**Wholesale Electricity Market – Submission to Procedure Change Proposal PC_2011_06
Five Yearly Review of the Methodology and Process for Determining the Maximum Reserve Capacity
Price**

WHOLESALE ELECTRICITY MARKET – SUBMISSION TO PROCEDURE CHANGE PROPOSAL PC_2011_06

Five Yearly Review of the Methodology and Process for Determining the Maximum Reserve Capacity Price (MRCP)

Graph 1: Merredin Energy – Open Cycle Gas Turbine S-curve

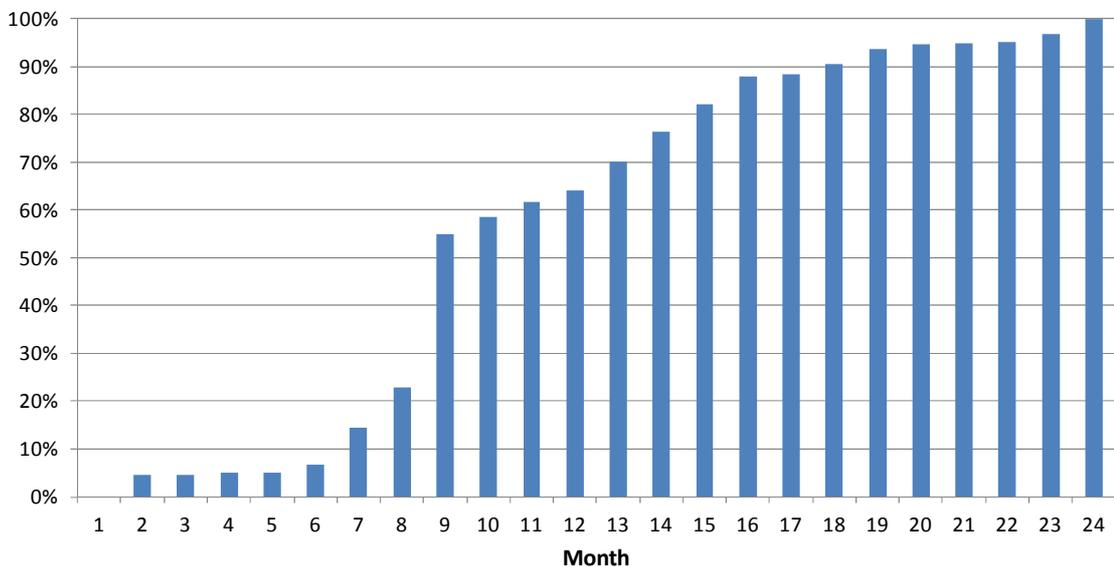
Merredin Energy’s view is that even a nine month mid-point spend is overly aggressive. The S-curve for the total project costs involved in commissioning our 82MW open cycle peaking generator is set out in Graph 1 below.

Significant costs under the Interconnection Works contract with Western Power were incurred in month 8 and in month 13. By the end of month 8, almost one-quarter of total project costs had been incurred. Around 30% of total project costs were incurred in month 9 due to significant instalment payments to General Electric for turbine units and to the EPC contractor for the balance of plant works.

The average S-curve value over the full 24 month period is 57.2%. This would suggest a gross-up factor of 14 months at the full WACC rate, and ten months at the reduced risk-premium rate:

$$(1 + \text{WACC})^{14/12} \times (1 + \text{WACC} - \text{risk free})^{10/12}$$
